## PCI-SIG ENGINEERING CHANGE NOTICE

<b>TITLE:</b>	Tx Blanking and SYSCLK on Socket 1 Related Pinouts
<b>DATE:</b>	October 19, 2014
<b>AFFECTED DOCUMENT:</b>	M.2 Spec Rev 1.0
<b>SPONSOR:</b>	Ra'anana Sover; Intel Corp.

Figure 87. Type 2226 SDIO Based Module-Side Pin-Out

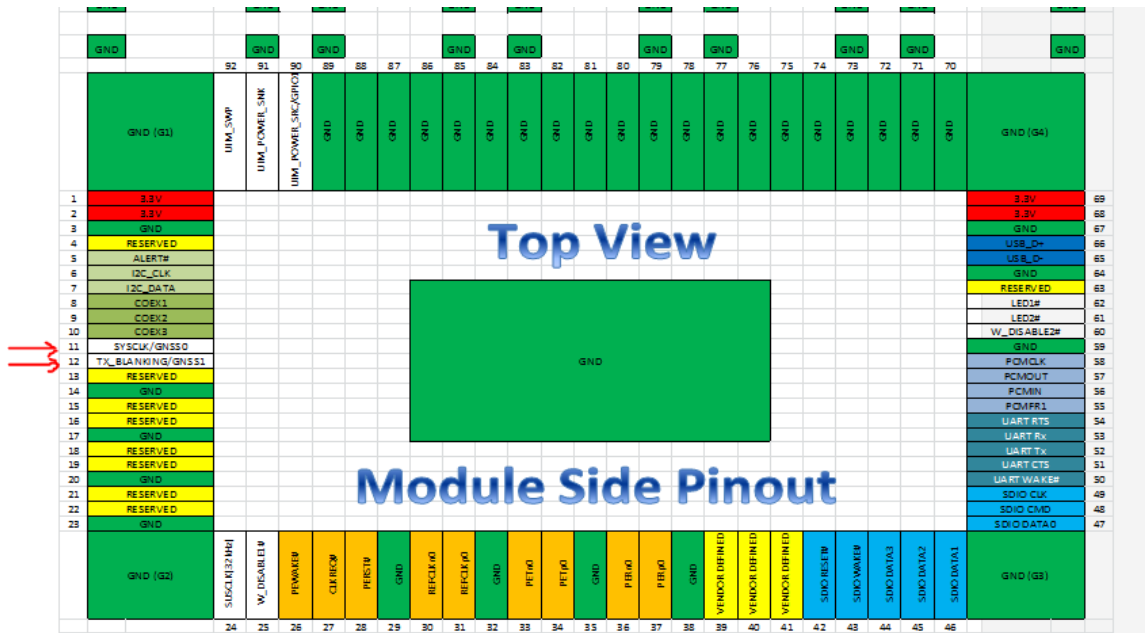
Update the Type 2226 pinout diagram in Figure 87 as follows:

Figure 89. Type 3026 Display Port Pinout Extension Over an SDIO Based Module-Side Pin-Out

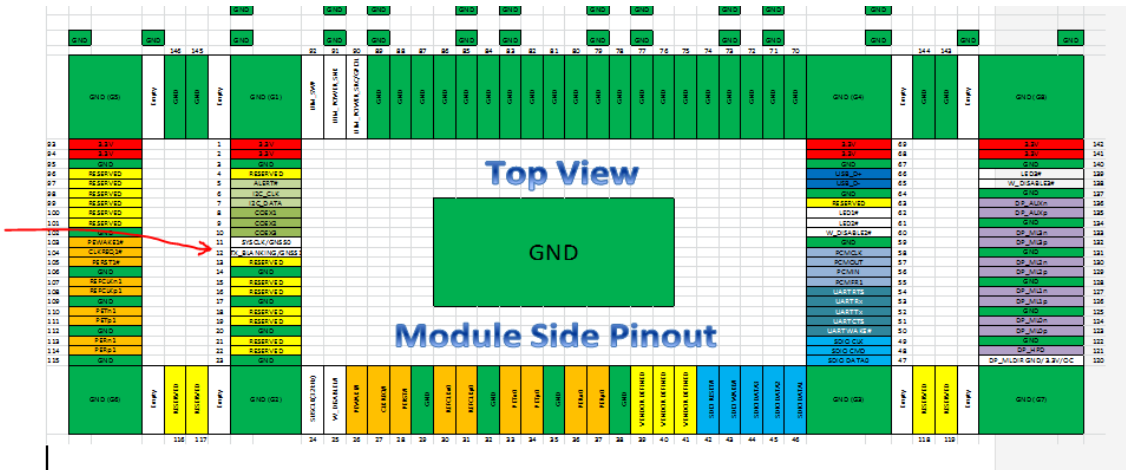
Update the Type 3026 pinout diagram in Figure 89 as follows:

Changes to pins 11 & 12

**Figure 91. Example Connection of the GNSS Signals in a Platform Using M.2 Modules**

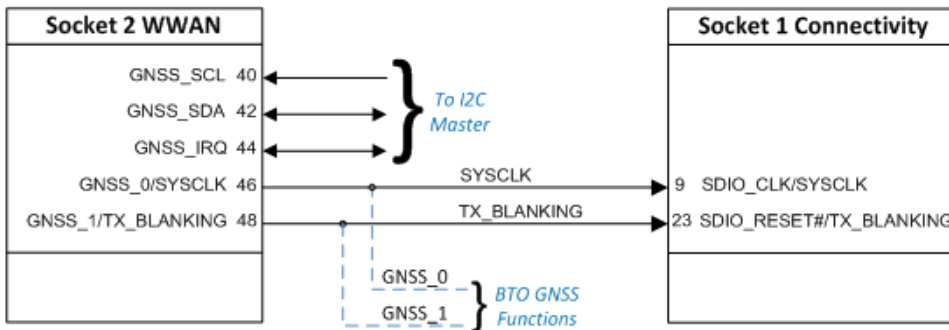
Add a complementary diagram showing an example of the connections of the GNSS signals in a platform system as shown above.

Figure 9493. Type 1216 LGA Pin-Out Using Socket 1-SD Based Pin-Out on Platform

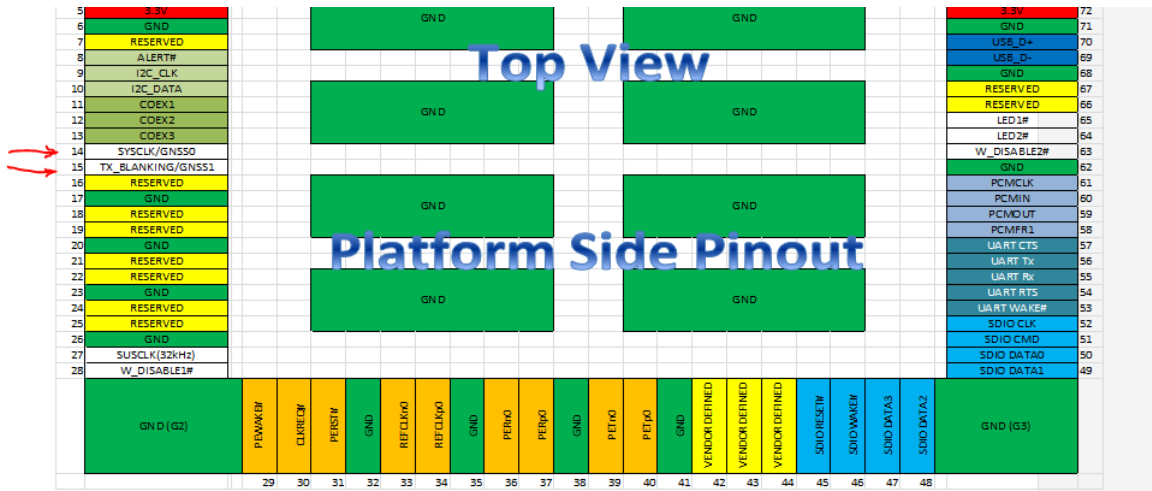
Update the Platform sidepinouts for the soldered down solutions. Update Figure 94 (was 93) as follows:

Figure 9594. Type 3026 LGA Pin-Out Using Socket 1-SD & 1-DP Based Pin-Out on Platform

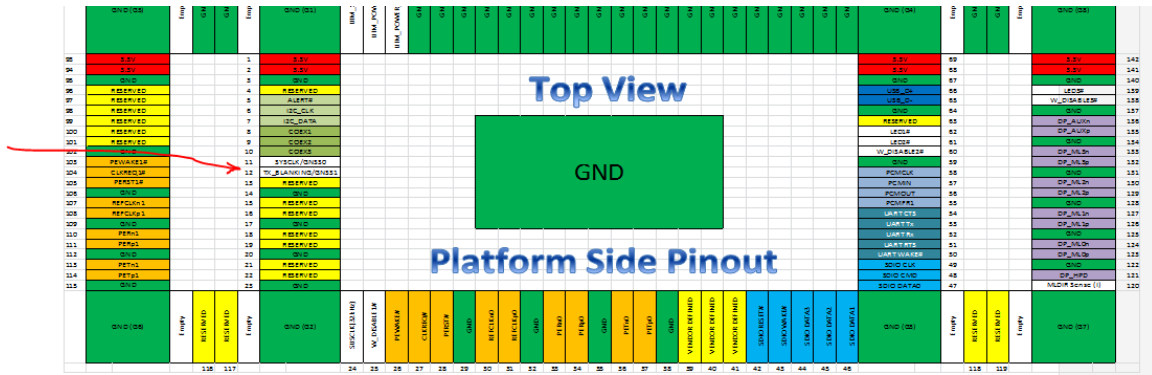
And update Figure 95 (was 94) as follows:
